Docket Number:	12-AFC-02C
Project Title:	Huntington Beach Energy Project - Compliance
TN #:	211134
Document Title:	Huntington Beach Wetlands Conservancy Comments
Description:	N/A
Filer:	System
Organization:	Huntington Beach Wetlands Conservancy/Gordon W. Smith
Submitter Role:	Public Agency
Submission Date:	4/18/2016 1:58:03 PM
Docketed Date:	4/18/2016

HBWC Comments on HBEP, 12-AFC-02C

RE: Huntington Beach Energy Project, Docket Number 12-AFC-02C, Petition to Amend

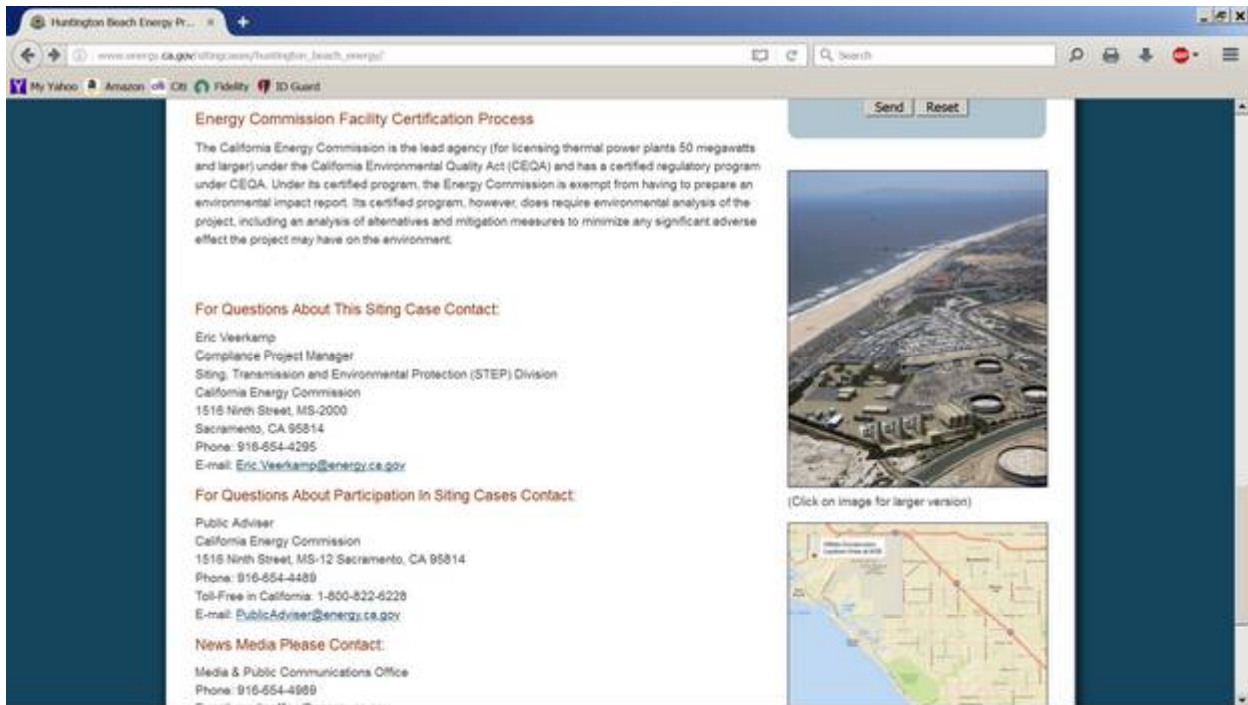
The above image is presented to show what is perceived by the Huntington Beach Wetlands Conservancy as misinformation presented by AES to the California Energy Commission, the City of Huntington Beach, and the public as the current state of fully restored wetlands immediately adjacent to the Huntington Beach Energy Project.

Note in this superimposed photo that the "Proposed" AES project (as shown before submittal of the Petition to Amend) appears to abut no wetlands and only shows only heavily tracked dry land adjacent to the Huntington Beach Wetlands. Briefing presentations by AES of the amended HBEP proposal use the same old photo of dry wetlands with the artist rendering updated to the revised site plan from the Petition to Amend as shown below. The background photo upon which this "Proposed" photo is inserted shows a representation closer to reality in that the restored wetlands are shown. The photo used in the artist rendering that is used in the "Proposed" photo appears to be from a much earlier photo (presumably earlier than 2009 as shown below) before any restoration of the wetlands was begun in 2010 and completed in 2011.
